CITY OF West Linn

STAFF REPORT PLANNING MANAGER DECISION

FILE NO.: MIP-14-07

REQUEST: Request for a 2-lot Partition at unaddressed parcel at the rear of 1722 and 1698 Eighth Avenue.

A 2 LOT MINOR PARTITION ON TAX LOT 700 MAP 31E 22BB

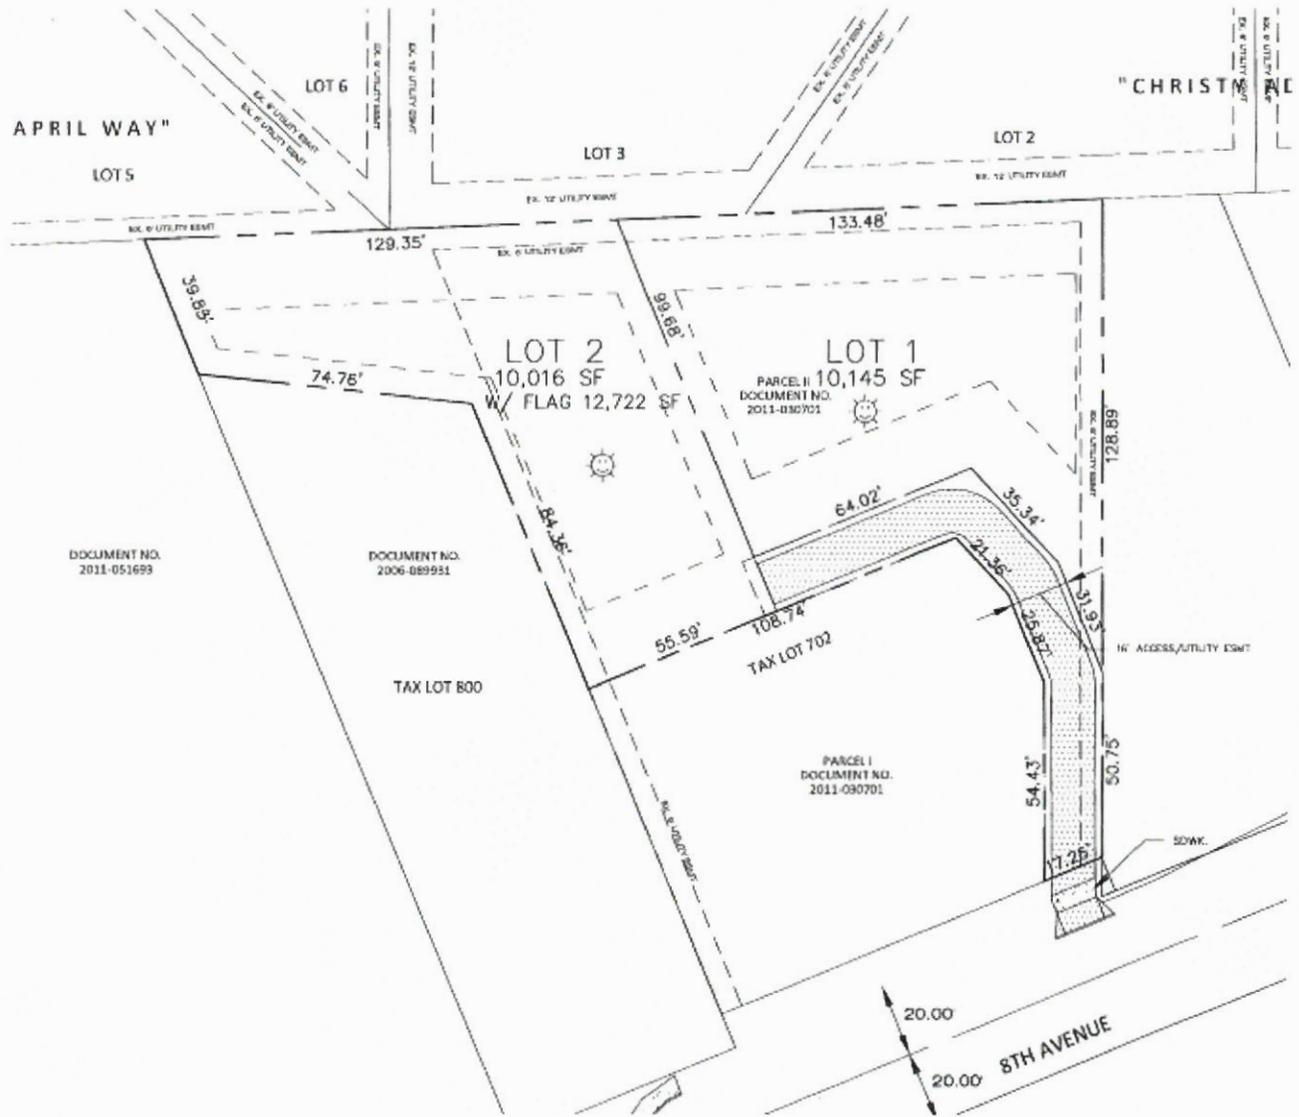
Staff has determined that the application meets the criteria of chapters 15 and 85 and hereby approves application MIP-14-07, as reflected in the Tentative Plan (dated 08/2014), with the following condition of approval:

1. Engineering Standards. All public improvements and facilities associated with public improvements including street improvements, utilities, grading, onsite stormwater design, street lighting, easements, and easement locations are subject to the City Engineer's review, modification, and approval. These must be designed, constructed, and completed prior to final plat approval.

2. Access and Utility Easement. The applicant shall provide and show on the face of the final plat a 16 foot wide utility easement and unrestricted access easement for the mutual benefit of lots 1 and 2. The owners of 1722 Eighth Avenue will be provided with unrestricted 16 foot wide access easement for the first 54.57 feet as measured from the Eighth Avenue ROW, as shown on the Tentative Plan.

3. Fees in lieu. The applicant shall provide fees in lieu for 17.25 lineal feet of half street improvements to include curb, half street and one street tree and excluding street lights.

4. Sanitary Sewer. Individual private sanitary sewer service lines to each lot shall be required.
5. Storm. The applicant shall direct storm water overflow from the treatment facilities to Christy Court via storm lines or shall provide an engineered on-site facility.

The applicant submitted four drawings, shown below, which describe different lot layout options and the possibility of a new minor partition to yield three lots.

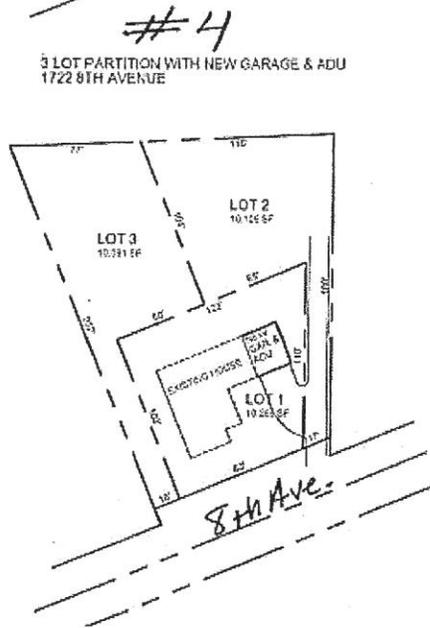
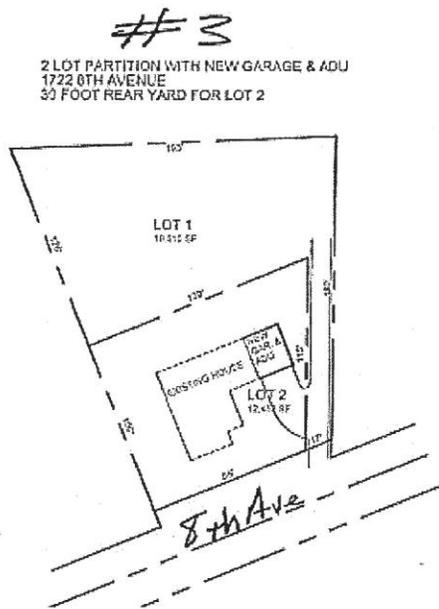
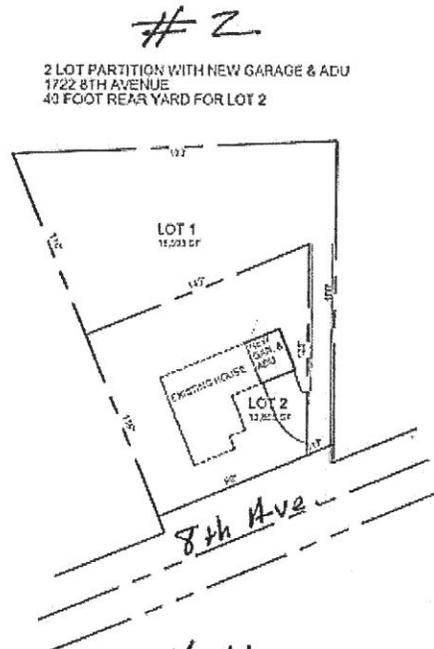
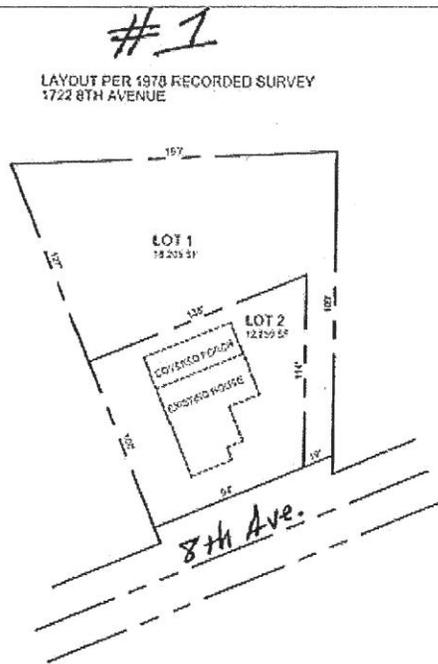
The proposal (drawing #4) would create a third lot at the rear by minor partition, with access via the west side of the existing house. This design would add a second driveway onto Eighth Avenue which is not permitted. Eighth Avenue is a local street per the Transportation System Plan (TSP) with a driveway separation requirement of 50 feet. The proximity of the west driveway to an existing driveway on the lot next door to the west would violate the TSP standard. Staff explained that there is internal conflict between the CDC 48.025(B) (6) and TSP (Table 8-3) on this subject and that there are practical reasons and a considerable amount of precedence that would lead staff to support a variance for the additional driveway. A Class II Variance would, however, be needed to allow that driveway.
